CERTIFICATE OF APPROPRIATENESS

Property: 1505 Oxford St, Lot 11, Block 136, Houston Heights Subdivision. The property includes a historic 2,100 square foot, one-story wood frame single-family residence situated on a 6,600 square foot (50' x 132') interior lot.

Proposal: Alteration – Addition *Deferral*

In October 2017, the HAHC deferred the application to construct a 1,973 square foot two-story addition to the rear and side of a 2,144 square foot one-story contributing residence. The applicant has made the following revisions to the addition's design:

SOUTH SIDE ELEVATION

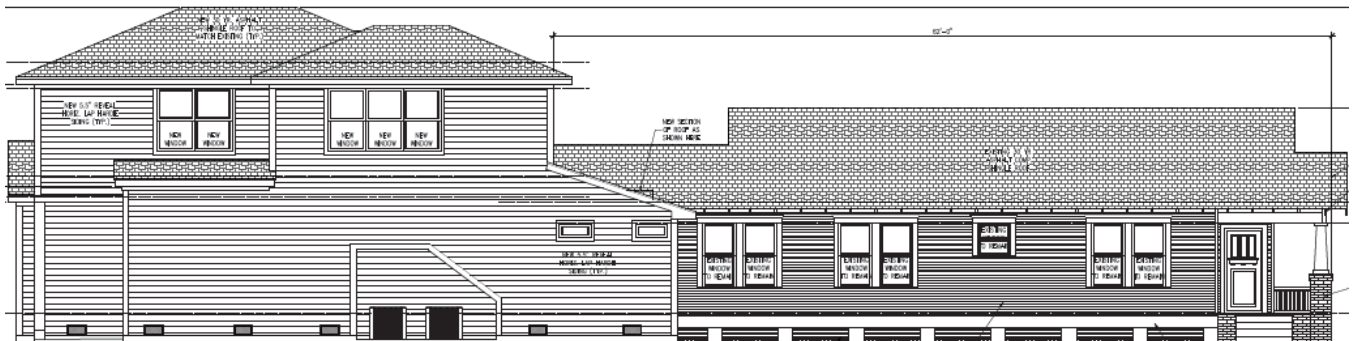
Proposed: The applicant has revised the fenestration pattern on the second level of the south side elevation of the addition. Please see p. 10.

SITE PLAN
EXISTING

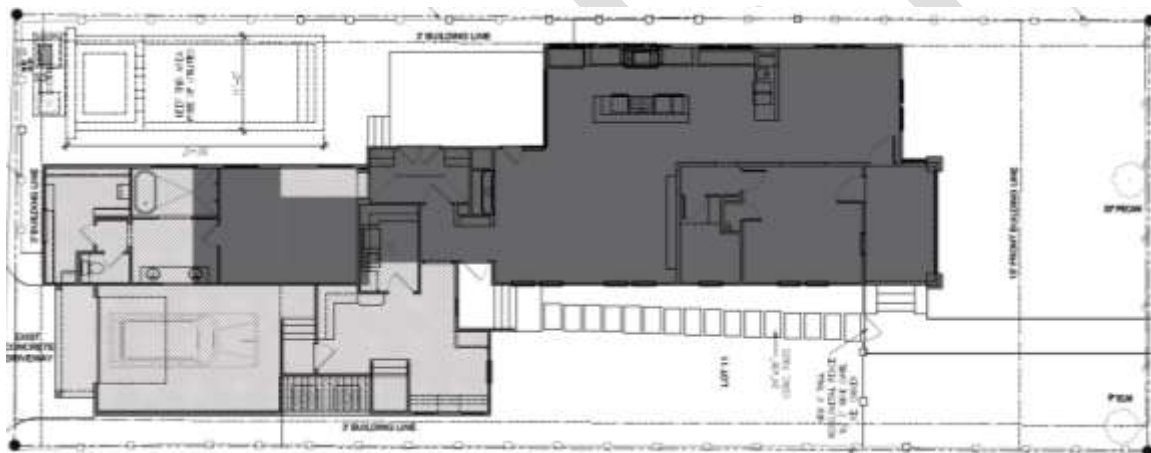
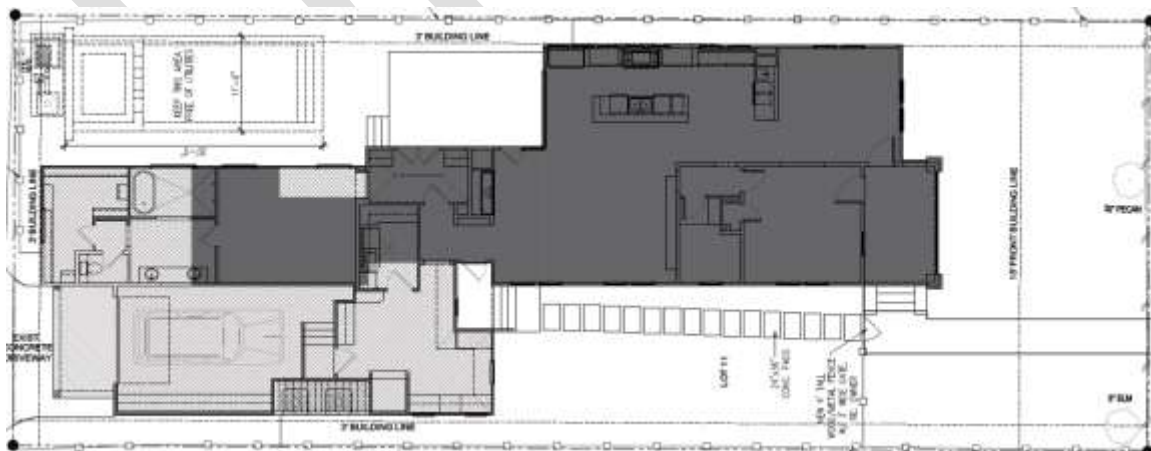
Deferred 10/19/2017: The proposed addition will be setback 12' and 3' from the side (north/south) property lines, and 3' from the rear (west) property line.

Proposed: No change.

ROOF PLAN

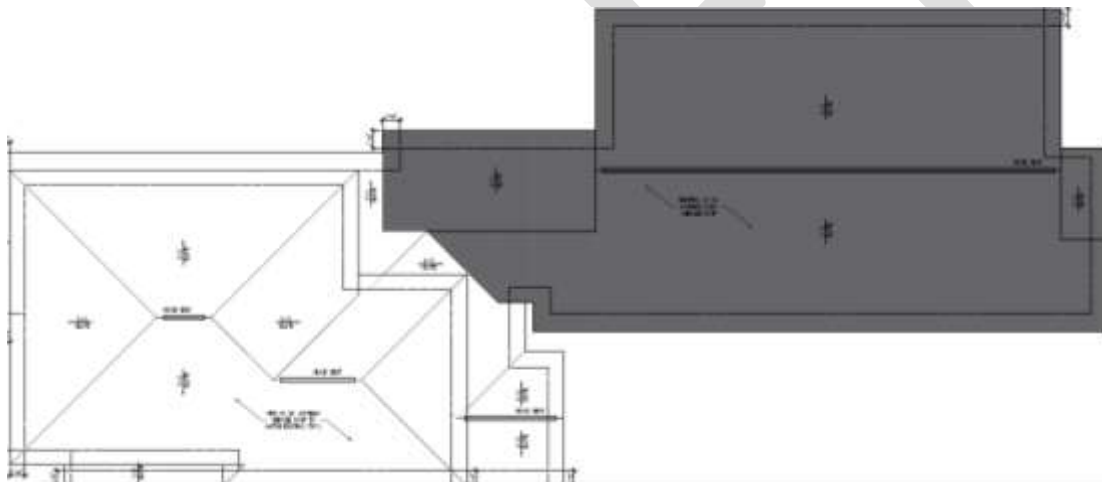
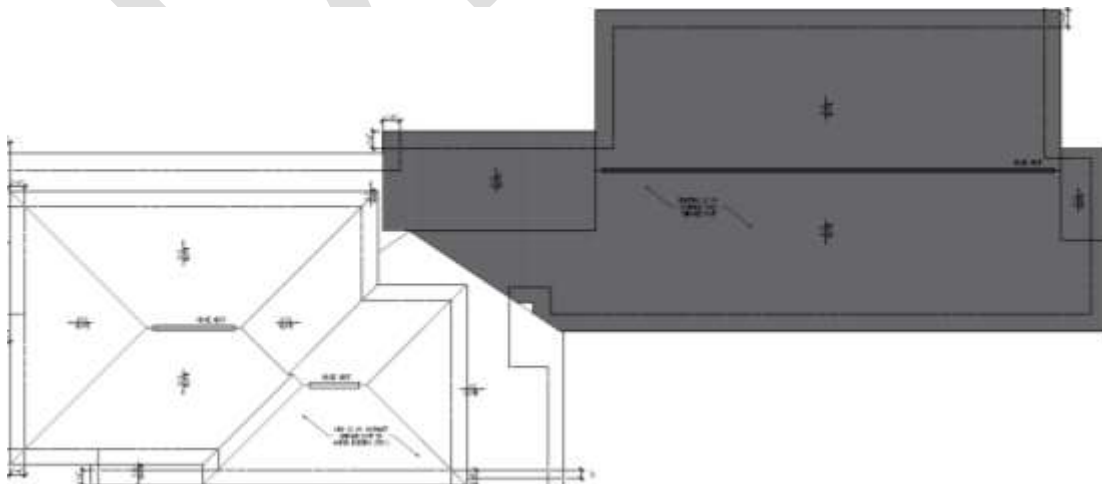
Proposed: The first level portion of the addition facing Columbia will have a shed roof and will cover the inset stoop. The roof will have a 4/12 pitch, a 1'-6" eave overhang, and a 9'-7" eave height. The second story eave height has decreased from 21' to 20'-5".
